**SUBMITTAL TO THE BOARD OF SUPERVISORS
COUNTY OF RIVERSIDE, STATE OF CALIFORNIA**

SUBJECT: REGIONAL PARKS AND OPEN SPACE DISTRICT: Approve Addendums to Plans and Specifications, Accept the Low Bid, and Award the Contract for the Hidden Valley Nature Center Modernization Project; Approve Allocation of American Rescue Plan Act (ARPA) Funds; District 2. [\$4,255,041 Total Project Cost – ARP Act Coronavirus Relief Fund 21735 94%; Park Acq & Dev, District Fund 33100 6%]

1. Approve PKARC-278 Addendums No.1, No.2, No.3, No.4, No.5, No.6, and No.7, to the project bid documents issued prior to the Thursday, September 12, 2024, opening;

Project:	Bid No: PKARC-278				
Hidden Valley Nature Center Modernization		Bid Date:	9/12/2024		
Post-Bid Questions/Protest Email:	Parks-Planning@RivCo.org

LANDSCAPE SHEET LC-2

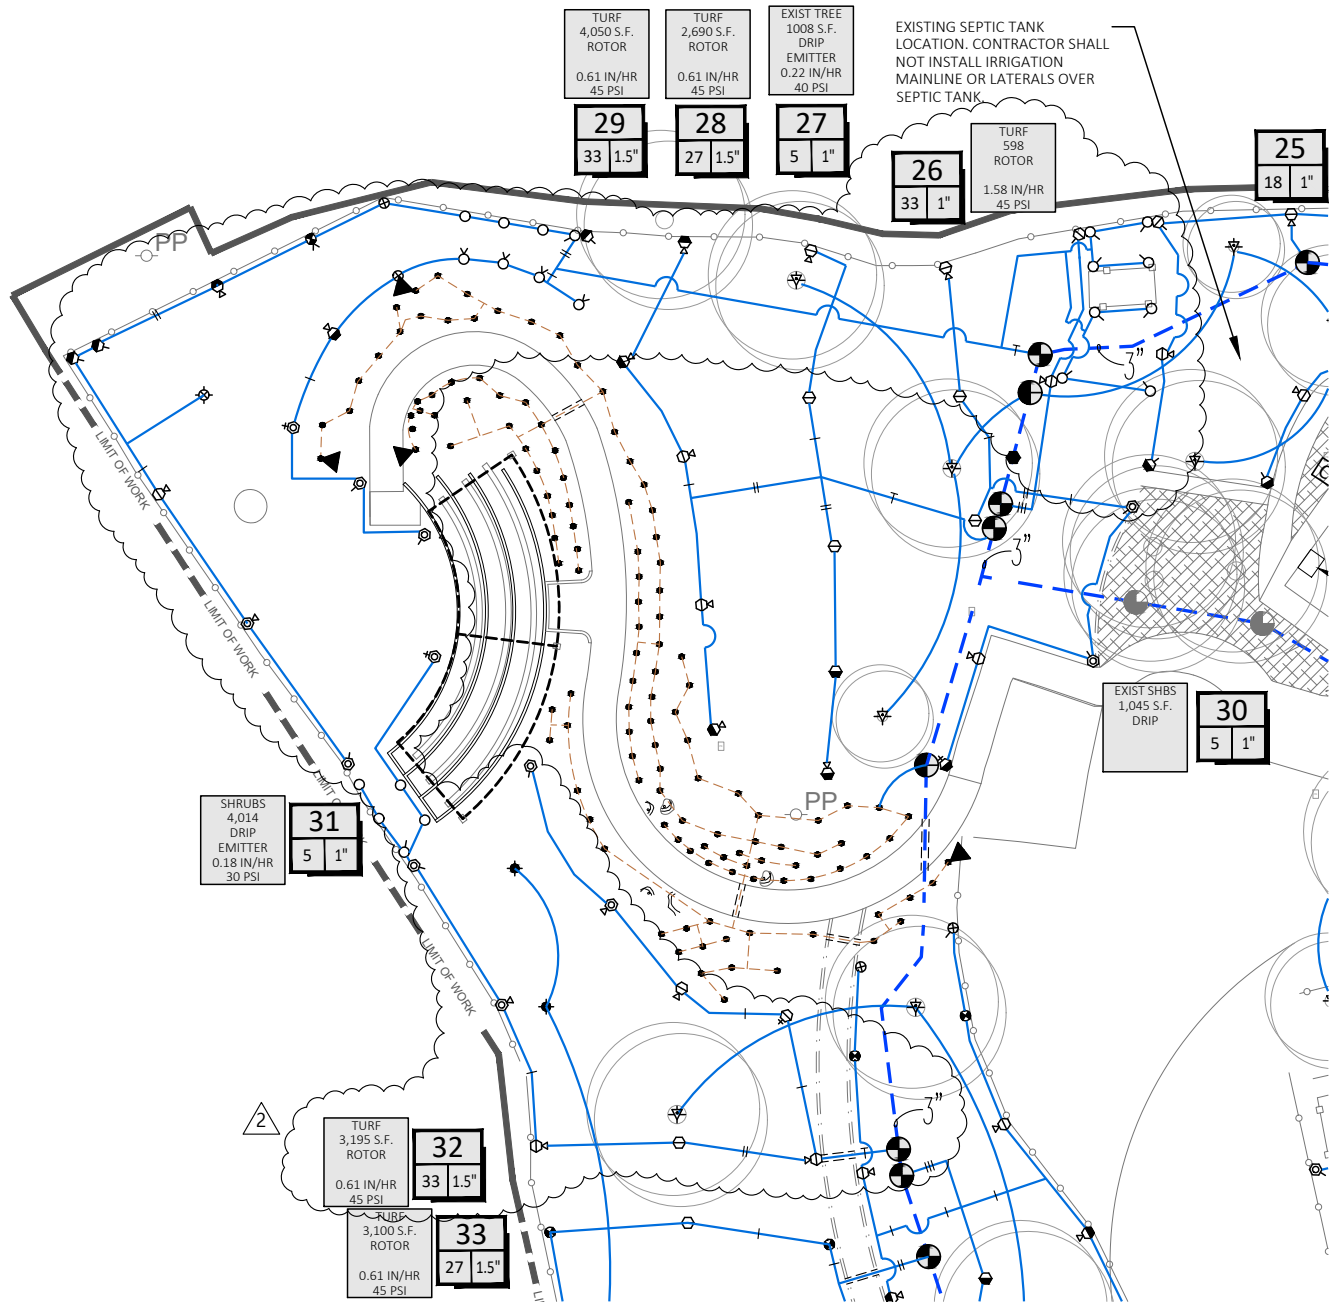
DESCRIPTION:
**ADDENDUM NO.6
PCC REMOVAL**

CONSTRUCT 4" NATURAL GRAY CONCRETE FLATWORK WITH MEDIUM BROOM FINISH, UNLESS OTHERWISE NOTED. STAINED CONCRETE PAVING. COLOR TO BE SELECTED TO MATCH EXISTING.		 7,654 S.F.	DETAIL 'A', SHEET LC-5
	CONSTRUCT 4" THICK CONCRETE FLATWORK. CHROMIX INTEGRAL COLOR C-27 'WESTWOOD BROWN'. STAMP LITHOTEX 'QUARTZITE STRATA' TEXTURE WITH LITHOCHROME A-24 'RUSSET' ANTIQUING RELEASE. AVAILABLE FROM LM SCOFIELD.		1,375 S.F.	DETAILS 'A' SHEET LC-5
